Model Review and Clarification for:

Hydraulic Models of the Congaree River in Richland and Lexington Counties, SC

Tuesday, April 24, 2001

Figure 1: Mesh used in FEMA study

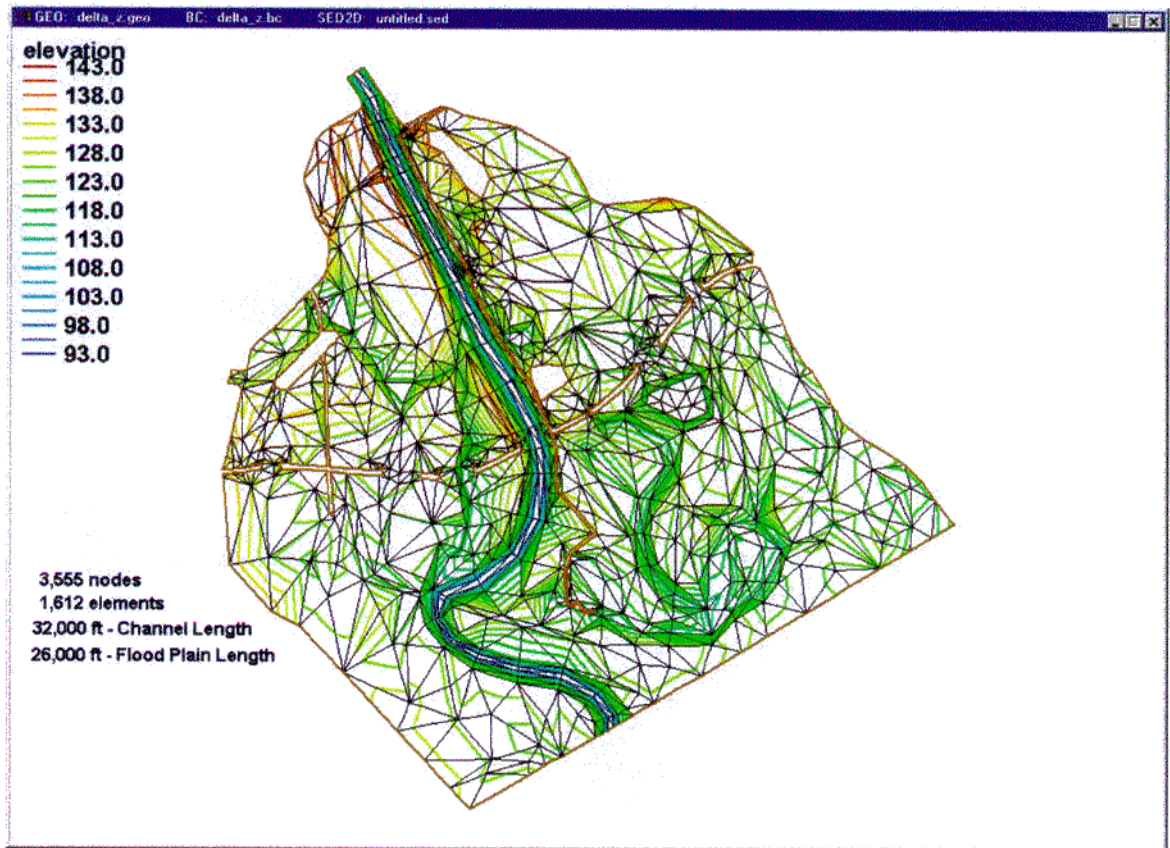
The FEMA study was based on finite element meshes originally constructed in 1981 by the USGS. For the study, two meshes were merged into one. The merged mesh is shown in Figure 1. The study is described in a report entitled "Appeal Resolution for Congaree River in Richland and Lexington Counties, South Carolina" dated September 26, 2000.

The FEMA study made use of an existing mesh in order to be efficient. This resulted in the model being limited to the resolution and extents of the older mesh. As has been mentioned, the downstream boundary condition was lower than was justified. A lower water surface would naturally result in higher velocities. The FEMA study used these higher velocities to delineate effective flow regions for the one-dimensional model. A larger effective flow region in the one-dimensional model results in a larger floodway. Therefore, the final conclusions of the FEMA study were significantly affected by the limitations of the old mesh.

Figure 2: Mesh used in Exponent study

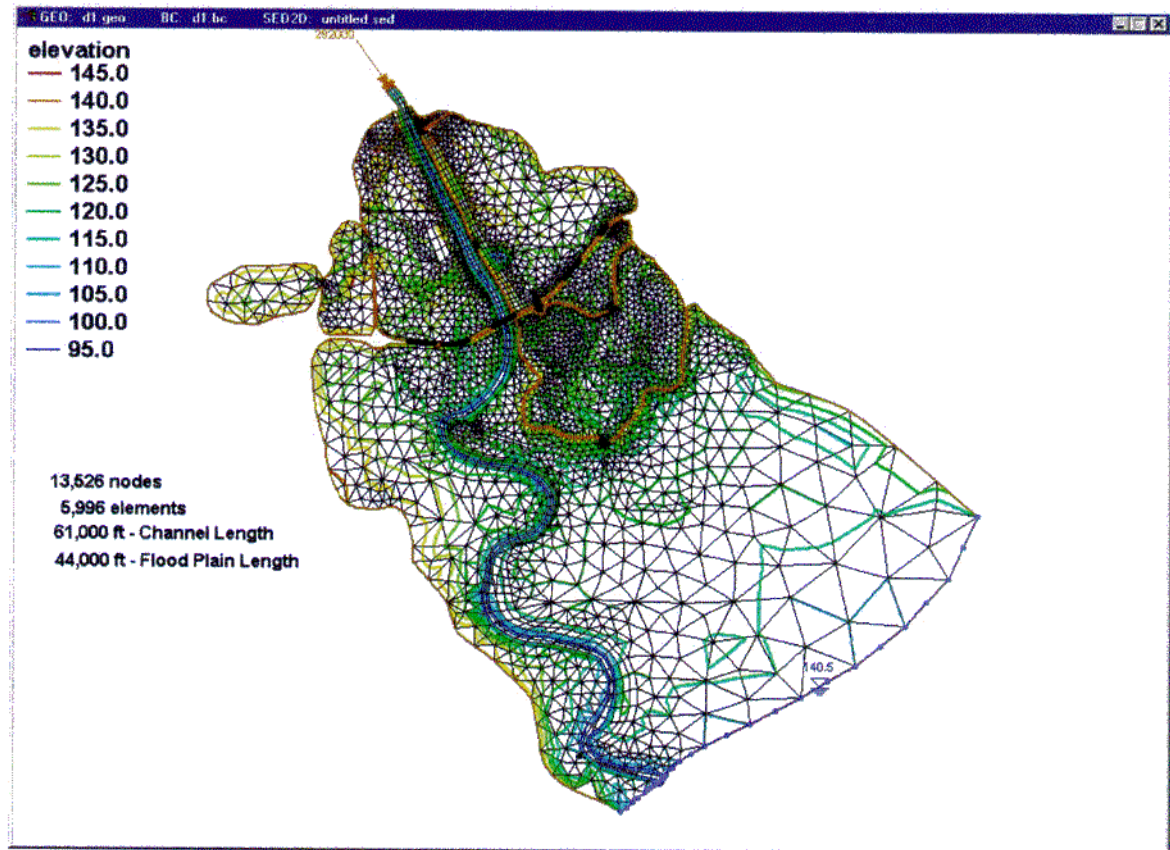
An expanded and refined finite element mesh was constructed for the Exponent study. This mesh is shown in Figure 2. The Exponent study is described in a report entitled "Expanded Two Dimensional Flow Analysis and Determination of No Floodway for the Congaree River Floodplain in Richland County, South Carolina", dated February 12, 2001.

The Exponent study resolved several of the problems which have been pointed out in the FEMA study. An improved mesh was generated to clarify the flow conditions. The extension to the model domain clarified how the downstream boundary condition should be specified. A more accurate representation of the geometry and material zones in the floodplain resulted in a clarification of flow conditions in general.

Several minor refinements to the Exponent mesh were suggested during the course of this review. These included some poorly formed elements, and numerical convergence concerns. Each problem was easily resolved and had no significant impact on the model results.

Figure 3: Difference in ground elevations.

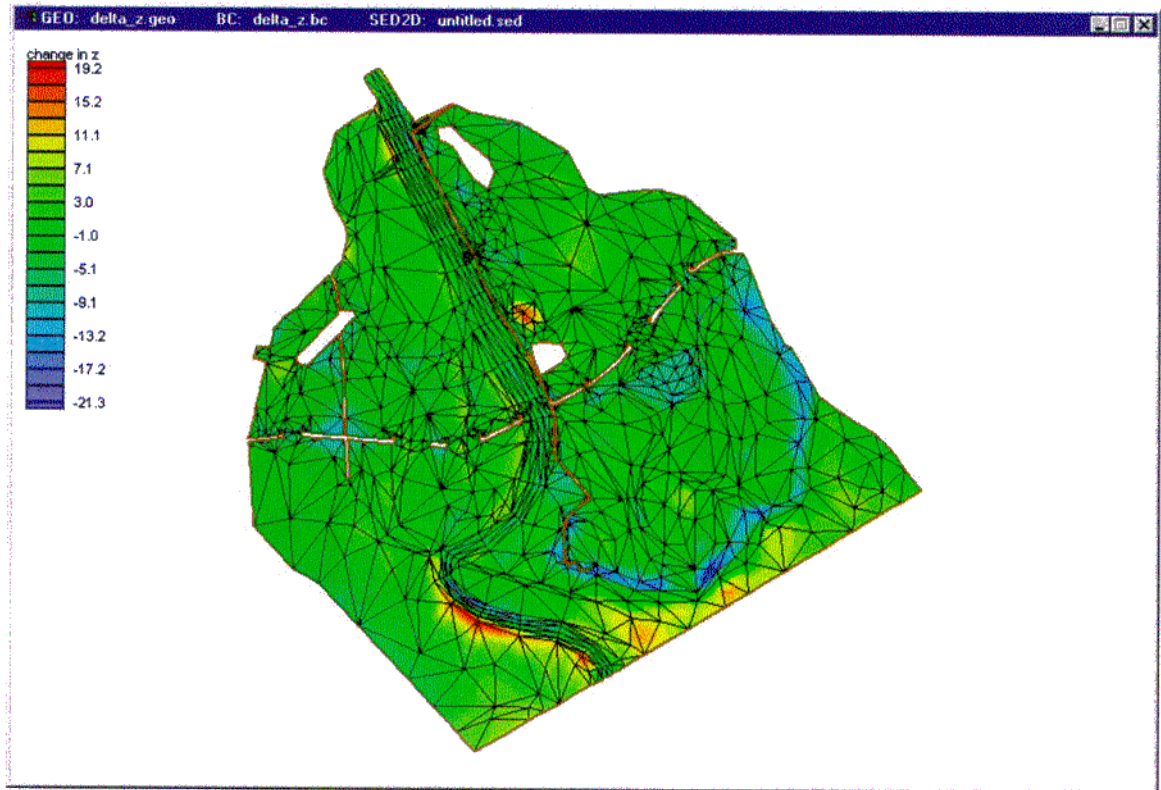
Underlying Data: No numerical model is better than the data used to construct the model. The geometry of a finite element mesh has by far the greatest impact of the accuracy of a numerical model. In the FEMA study, the principal source of bathymetric data was from the 1981 USGS study. FEMA indicated that they had compared these data with updated contour maps to check elevations, and this resulted in higher elevations in some of the areas behind Manning Levee. The Exponent study used entirely new geometric data obtained from recent surveys. Comparison of the geometry (Figure 3) show that in the principal areas the ground elevation used are very similar. The blue areas below the I-77 embankments illustrate the difference in representation of the Gill Creek Levee. The FEMA study has higher ground elevations, whereas the Exponent study modeled the levee as a flow restricting feature (similar to the I-77 embankment). The biggest difference is the extent of the data. Figure 3 shows the extent of the FEMA study, because that is where a comparison can be made. However the Exponent study extends 16,000 ft further down the floodplain.

Figure 4: Mesh quality warnings

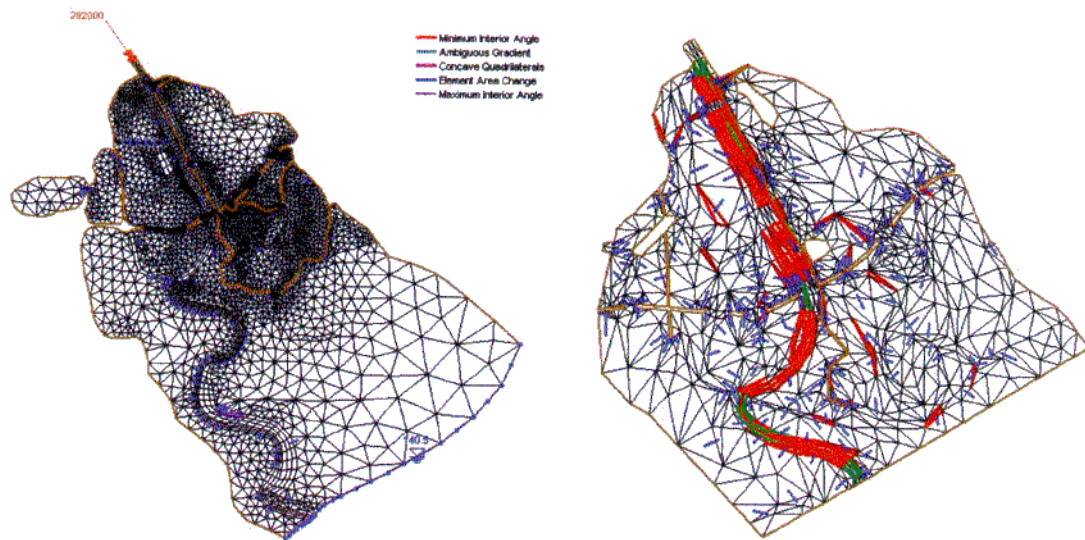
Mesh Quality: Mesh quality includes analysis of element quality, element density and resolution, and domain extents. The shape, quality, and number of elements in an RMA2 model have an affect on its stability and validity of the model results. Skewed triangular elements in particular with interior angles less than about 10° can produce erroneous results. SMS includes an option to display warnings about mesh elements that violate these rules. Figure 4 shows the warnings that were generated for the standard recommendations in SMS for the two meshes. In these pictures, any color indicates a possible concern. These figures indicate a superior quality of the Exponent mesh.

A higher resolution of elements increases the computation time required but can produce more a accurate solution due to more points of computation. The 2000 FEMA study used a finite element mesh that was originally prepared by the USGS in 1982. At the time of the original study, lack of efficient interface tools, time and cost limitations did not allow for a more developed mesh. Although the SMS technology was available in 2000, it was apparently not used to its full potential because the original rough mesh from 1982 was utilized in the FEMA study with only modifications of updated bathymetry. The Exponent study took advantage of the SMS tools and developed a new finite element model. There was much better mesh refinement in the Exponent study than in the FEMA study, leading to a higher resolution in the solution.

Figure 5: Velocity magnitude parallel to the river.

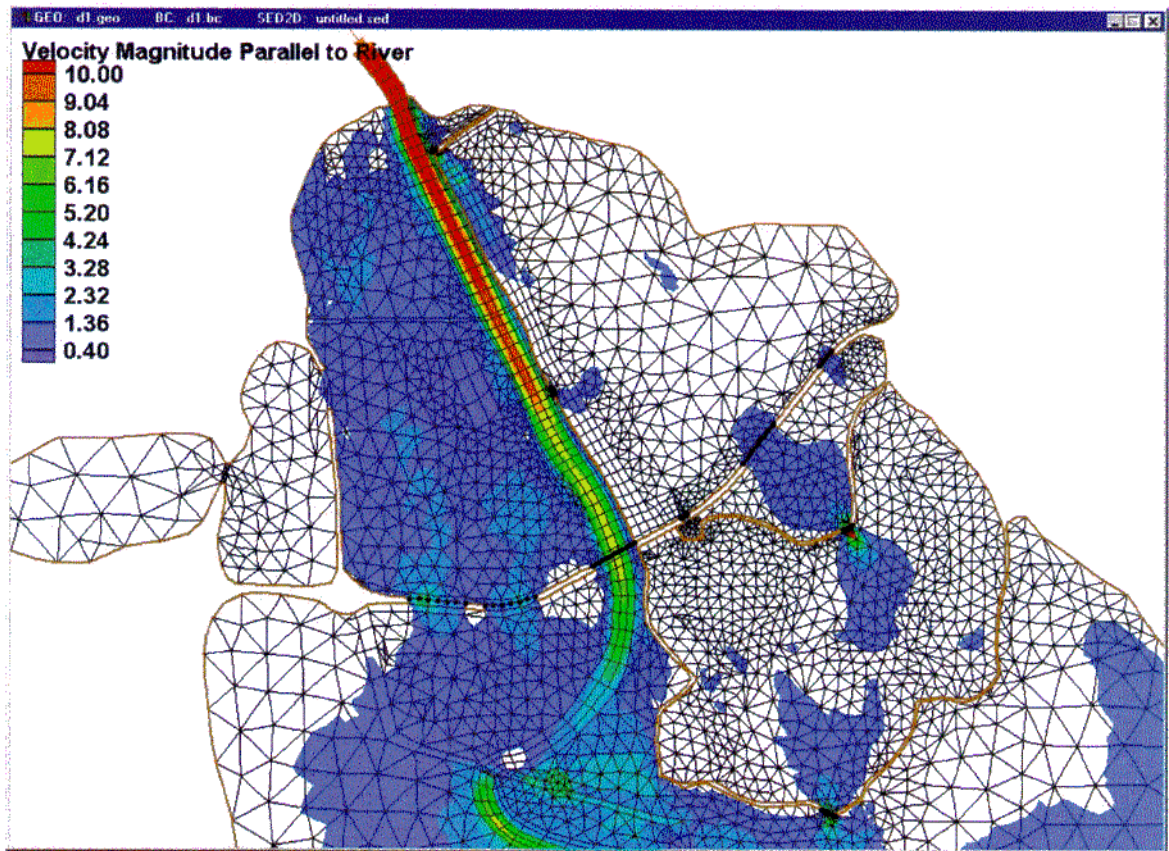
When determining if the flow in the Richland County floodplain is a floodway, the flow conditions need to be examined. If there is no efficient flow, there cannot be floodway. The FEMA study established a 1 ft/sec velocity magnitude for effective flow. However, behind the Manning Levee, the flow direction is not parallel to the river. The velocity magnitude parallel to the river can be computed using the tools inside SMS. For the 1% flow rate, for what Exponent called CASE 3 (two breaches of Manning Levee), the areas where water is moving parallel to the river faster than 0.4 ft/sec are shown in Figure 5. This figure shows that water does not flow in an efficient manner that would be expected in the floodway. This clarifies the condition of flow behind the levee.

Historical Factors

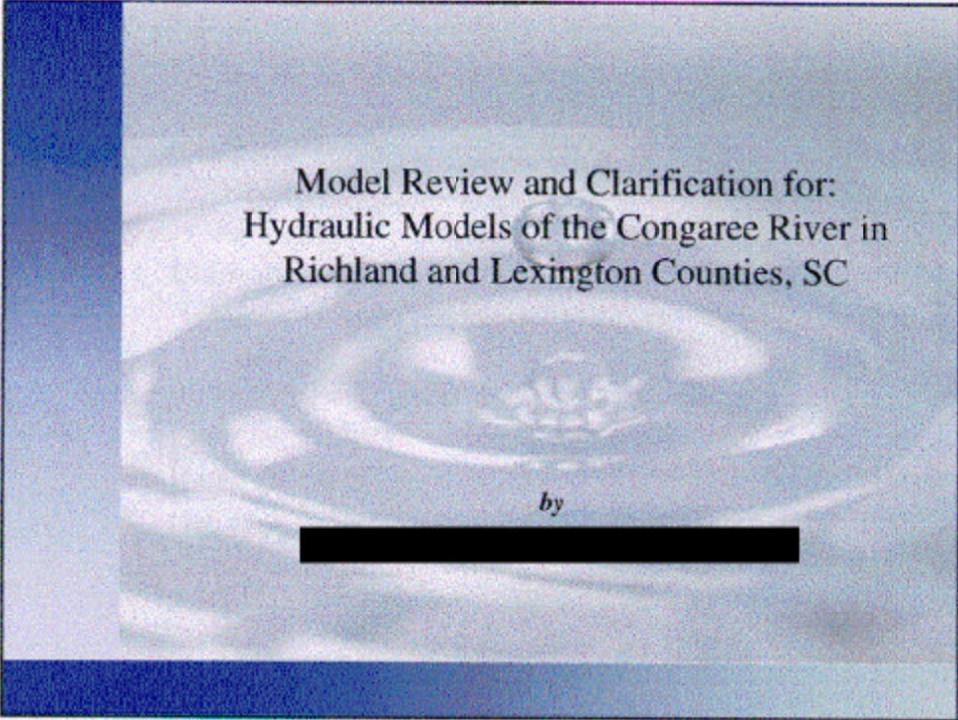
By strict definition, Manning Levee is not a 100 year levee, and therefore could be ignored when computing a floodway for the Congaree River. However, it has not been ignored in other hydraulic design considerations over the past several decades. The I-77 relief openings were obviously designed without a floodway in mind. This is evidenced by the fact that the large 1300-foot relief opening is not positioned near the river (which probably would create an efficient floodway), but rather in the middle of the floodplain. While it is true that a Manning Levee breach is expected during the 1% event, and that such a breach will allow up to 9% of the flood waters to pass through Richland County, it is also true that the levee significantly modifies the hydraulic nature of the floodplain. It does this by its own existence as well as through the influence it has had on other levees and embankments that have been added to the floodplain since it was built.
